NORTH EAST CAMBRIDGE  
TOWNSCAPE STRATEGY

**APPENDIX:  
DRAFT AREA ACTION  
PLAN REVIEW**

FINAL REPORT  
SEPTEMBER 2021

1.1.1 This Appendix provides an independent review of the Draft North East Cambridge Area Action Plan (2020) undertaken by consultants Urban Initiatives Studio.

Figure 2.8 Illustration of proposed secondary street design (draft NEC AAP)

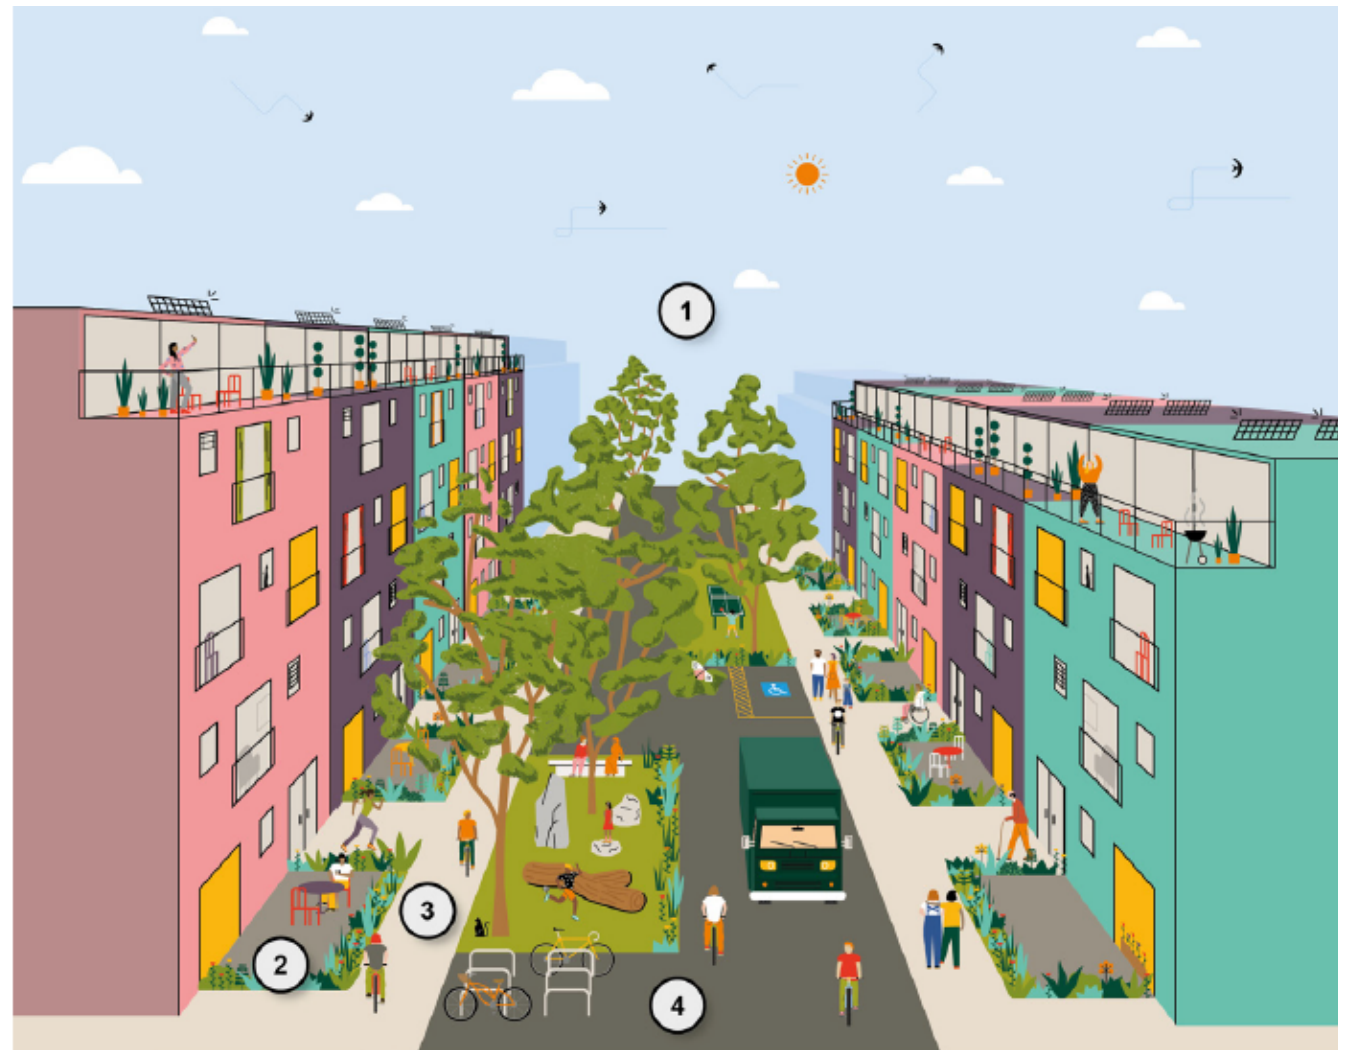
- The shared streets approach can work for residential streets with little traffic demand but not for the main streets passing through the area to the industrial area and Cambridge North Station.
- 2m footway may be too narrow in places.
- Providing small recreation areas in the street is welcome but mixing children's play with traffic may not be best option for either use (residual risk).
- Who will look after the street and public space elements?

- Street design should reflect the role of the street in the network and the kind of traffic it will receive (including bus and car).
- Consider the social dimension of street and how pedestrian movement can be concentrated so there are opportunities for encounter and meeting.
- Consider that during the night time pedestrians prefer to walk along busy vehicular streets for added security.
- Consider pocket spaces away from moving traffic.
- Provide appropriate space for cyclists and minimise conflicts with pedestrians. Cyclists can use vehicular space and reserve footways for pedestrians.
- Prepare design codes for specific street types.
- Prepare a street network plan that sets out principal routes across the NEC area that development should implement.

Figure 4.1: Structure diagram (draft NEC AAP) annotated to show locations of centres and walking radii as proposed in AAP

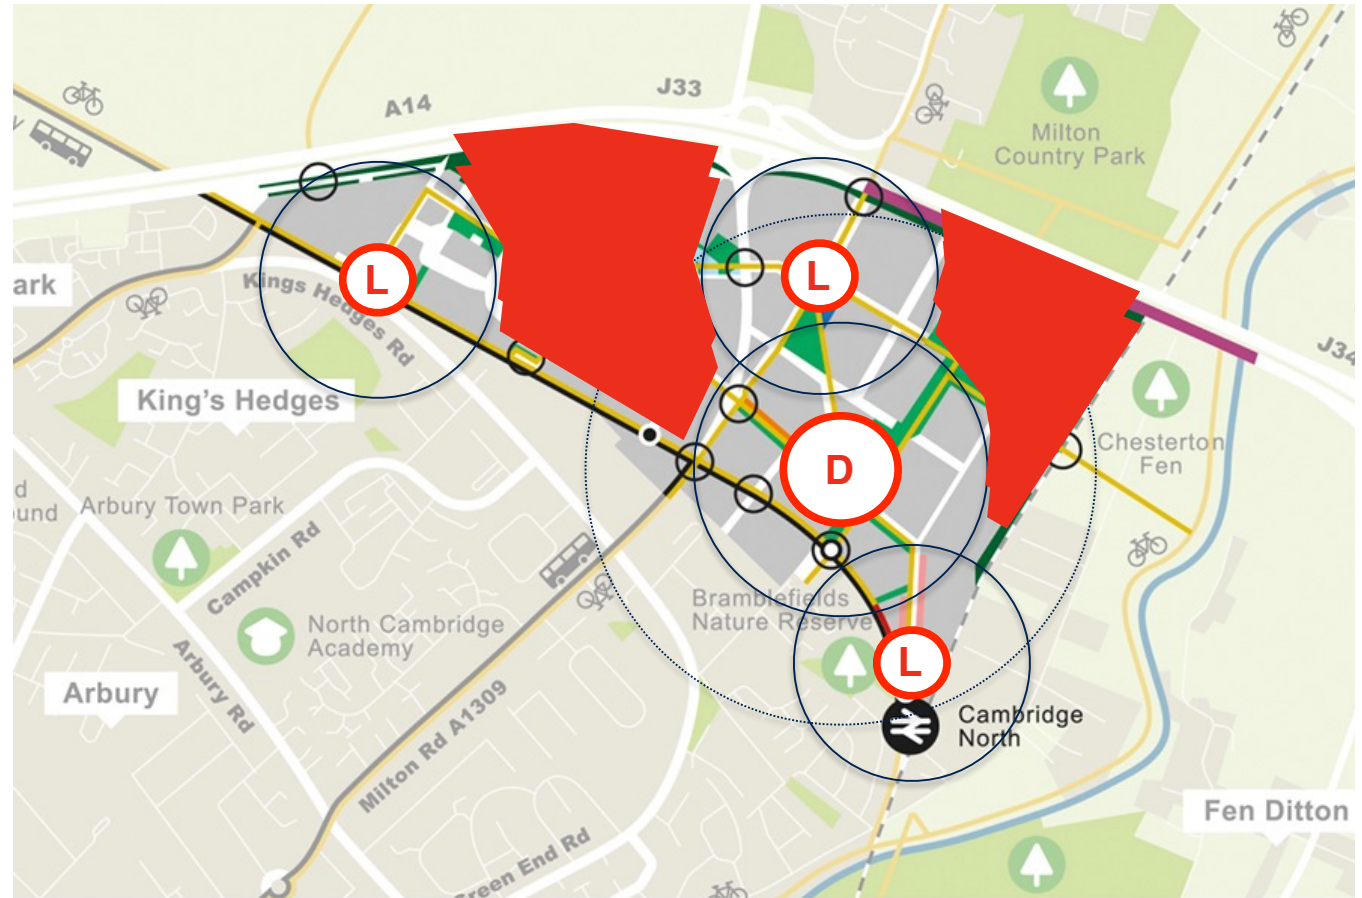
- The rationale for the proposed locations of centres is not clear.
- Local centres perform local convenience role (convenience store, local independents, cafe, restaurant, bar, take-away) for their immediate hinterland and should be no more than 5 minutes away.

- District centres also perform local convenience role to their immediate hinterland (5 minutes walk). They also provide destinations and concentrations of uses (supermarket, shops and services, culture and leisure uses, range of eat and drink uses, evening economy, library) for larger catchment (10 min walk, cycle, public transport, car access) - opportunity for trip combination.

- Current centre locations shows poor convenience provision in north-east corner meaning people will be likely to drive.
- The District centre is:
  - hidden away and not visible from main vehicular and bus route through area (Milton Road), and unlikely to attract custom from King's Hedges, Chesterton and Milton;

- only properly serves the NEC's eastern part, but not Cambridge Science Park; and
  - lack of buying power from office workers during the day and lunch time will affect its range, vitality and viability.

- For centres to work - they need to be natural hubs of activity due to their 'central location' in the route network and be highly accessible.
- Centres without high accessibility, prominence and visibility and a sufficiently dense hinterland that supports their convenience function are likely to struggle or fail.

Figure 4.4: Structure diagram (draft NEC AAP) annotated to show distance to North Cambridge Academy Sports Centre

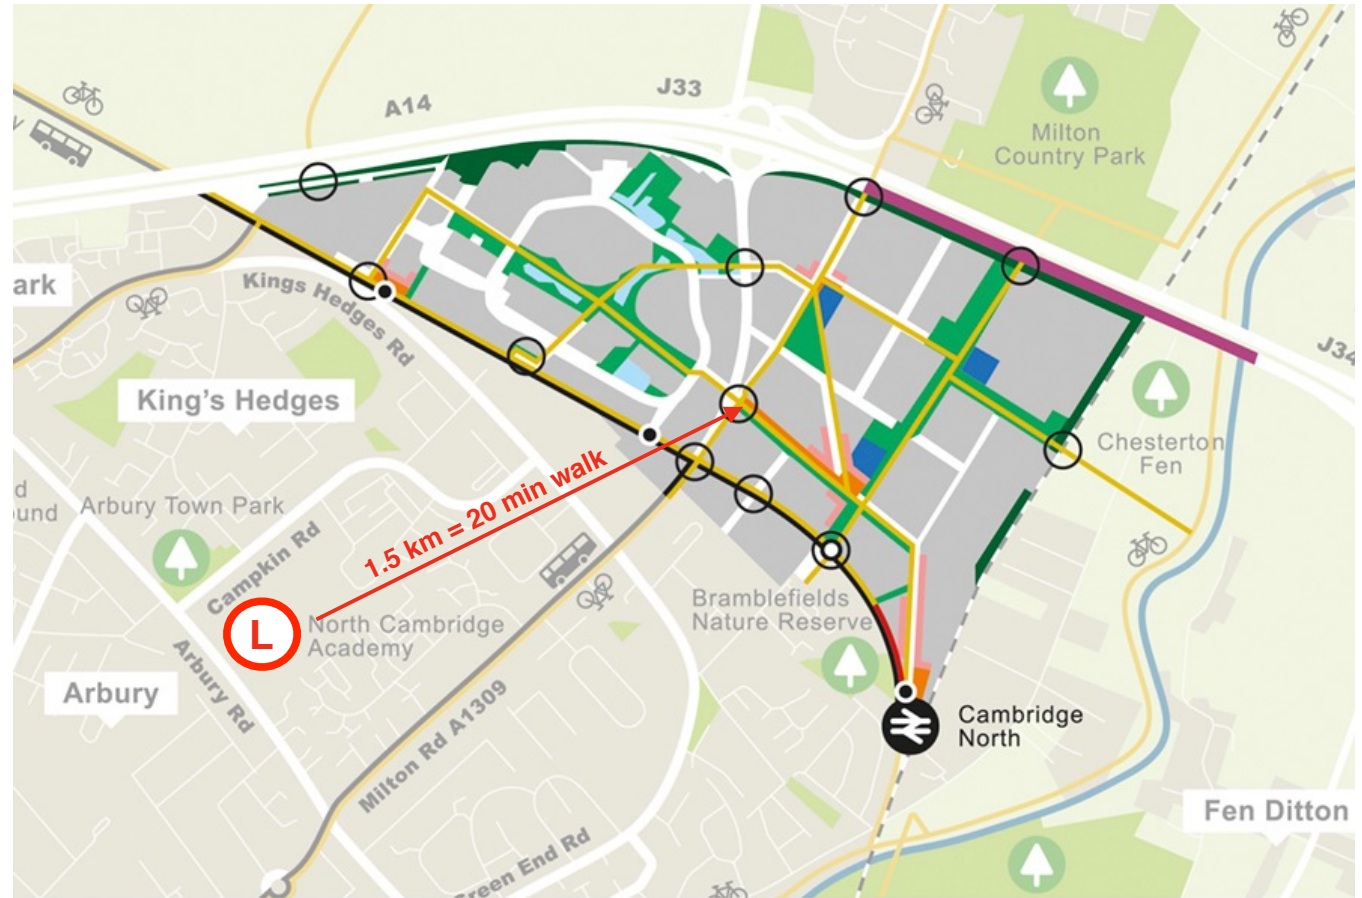
- Does this say the leisure centre for this area is located elsewhere?
- Where? At North Cambridge Academy? 20-40 minutes walk away
- How do residents and workers get to it?
  - cycle, PT or car?

- It would be beneficial to support NEC with a new leisure centre to serve new residents and office workers in the area in central location that is also accessible from surrounding neighbourhoods. Centrally located this could also generate footfall to support district centre.
- However, if this is not possible, then it is important to provide high quality walking and cycling routes to nearby leisure facilities.
- Maximise on the offer by Cambridge Regional College of indoor and outdoor formal sports provision to the wider community and enhance walking and cycling connectivity with the college

Figure 4.6: Industrial co-location concept diagram (draft NEC AAP)

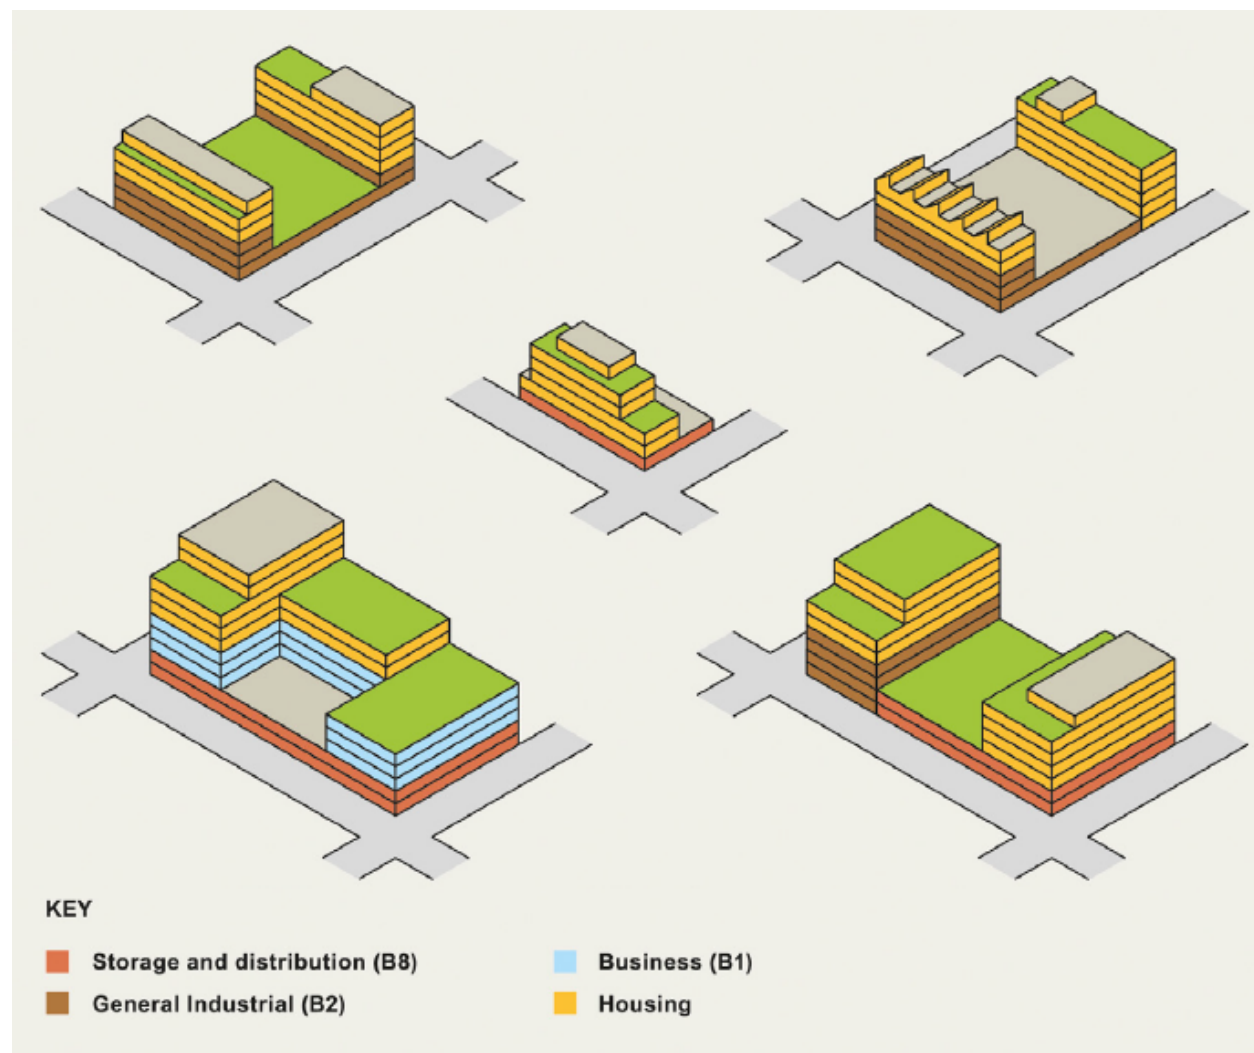
- The draft AAP proposes Industrial Co-Location but is this viable?
- Does it deliver the type of industrial spaces and flexibility needed in the Cambridge context?
- Is there demand for this type of housing - likely Built to Rent?
- Need to avoid externalities such as noise, odour, vibration, fire risk and allow for 24/7 access.
- The 'Agent of Change' principle is required to protect existing or new industrial uses.

- More conventional but compact industrial layouts that are spatially separated from housing by using back to back and courtyard typologies, or being set against the rail line.

Figure 5.2: Net density diagram (draft NEC AAP)

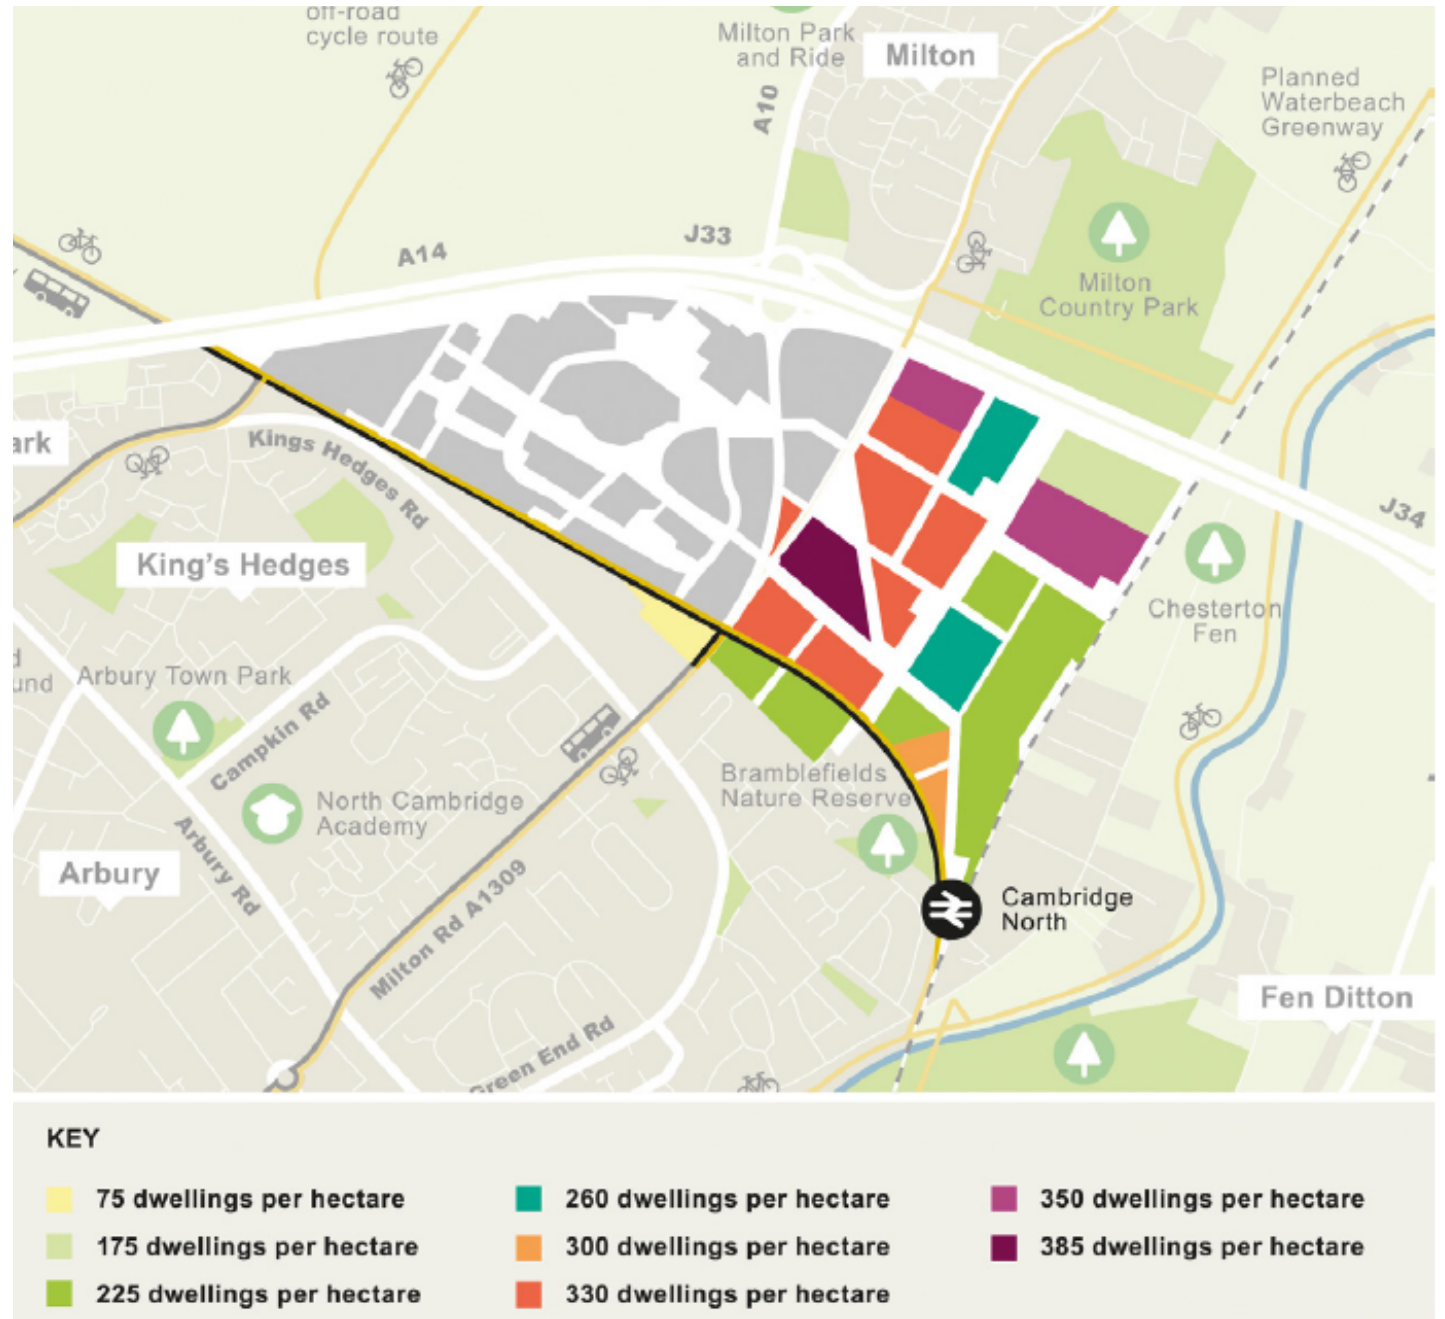
- It is unclear how the proposed development densities have been determined and what their underlying rationale is.
- How do the proposed densities relate to the building height plan?
- Why do densities drop in more central areas and increase in outer areas? Is this consistent?
- Given the plan stipulates heights and quantity of development, do we need to specify densities?

- Density should be an outcome of good design, not a determinant.
- It is suggested to not require densities as such but set other parameters for good design.
- Use density to establish the need for open spaces and other infrastructures.
- Where density is highest the more people will live, work and visit - it has the highest need for public open space within 5 minutes with most people benefiting from it.

Figure 5.3: Residential density (homes per hectare), showing density of NEC based on AAP proposals

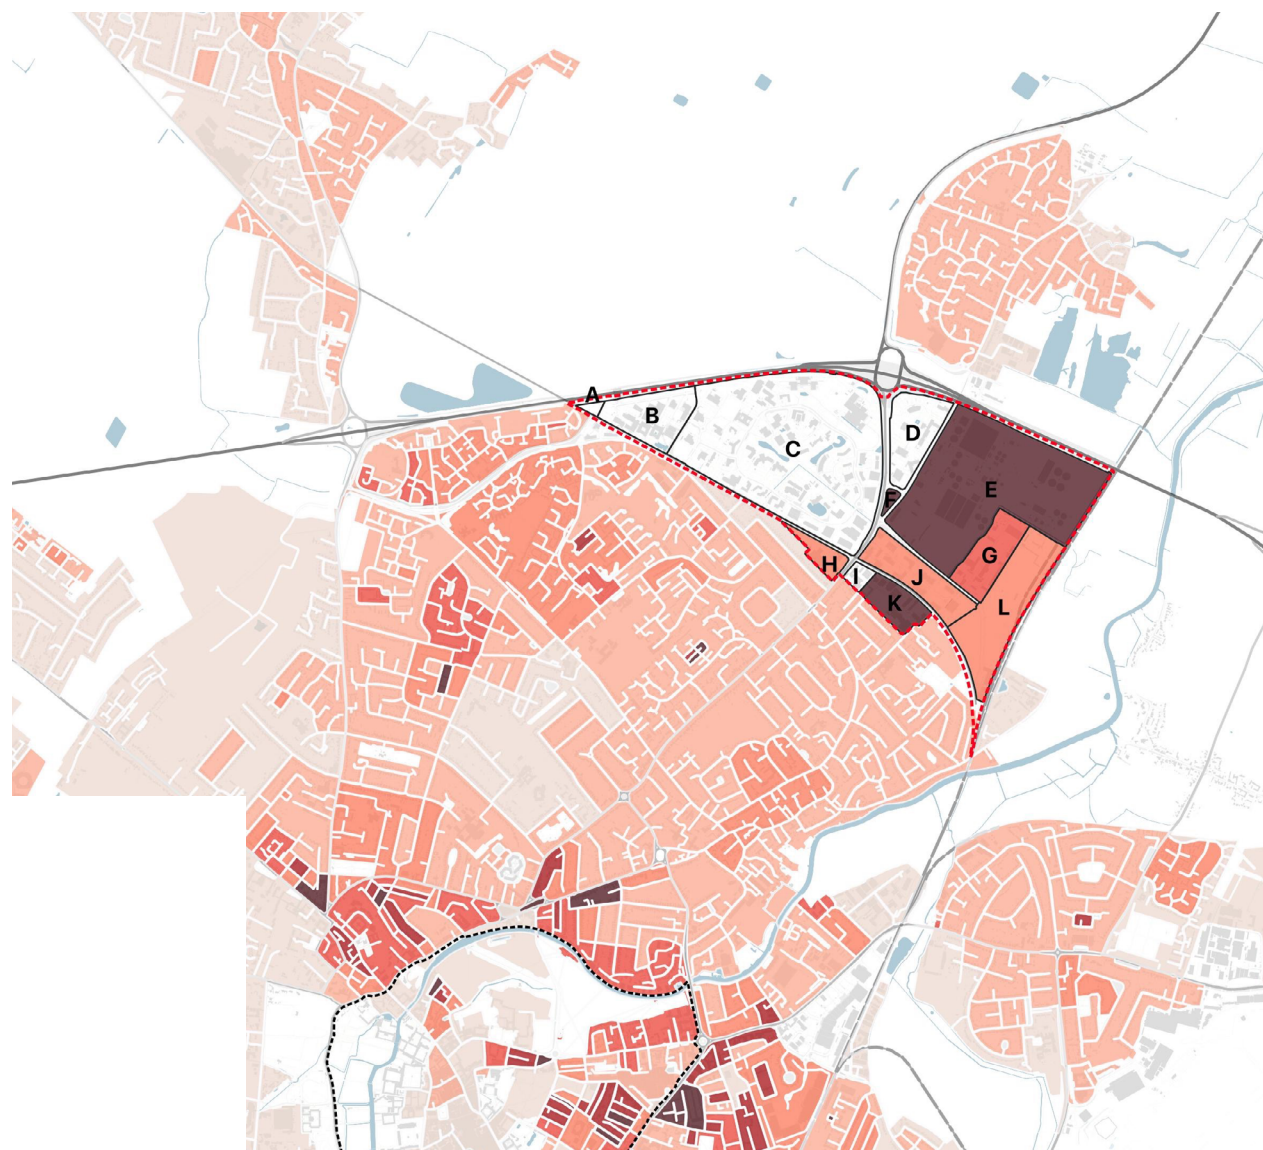
- An analysis of the gross densities (plot ratio) of the draft AAP proposals has been undertaken to support this review.
- The plot ratios are as follows:
  - 0.5 to 0.8 in office parks - comparably low
  - 1.08 at Nuffield Road Industrial - urban
  - 1.4 at the Waste Water Treatment Plan - urban / intense
  - 1.77 at Cambridge Business Park - urban / intense
  - 2.78 Merlin Place (outlier as small site) - highly intense
- Densities in some areas appear high in the Cambridge context, but are not uncommon in urban regeneration areas. They will require a high quality approach to design and development.

- Council is invited to review the underlying assumptions on development numbers and the distribution of housing across the site.
- Can more housing be provided to the west of Milton Road and densities reduced in the east?
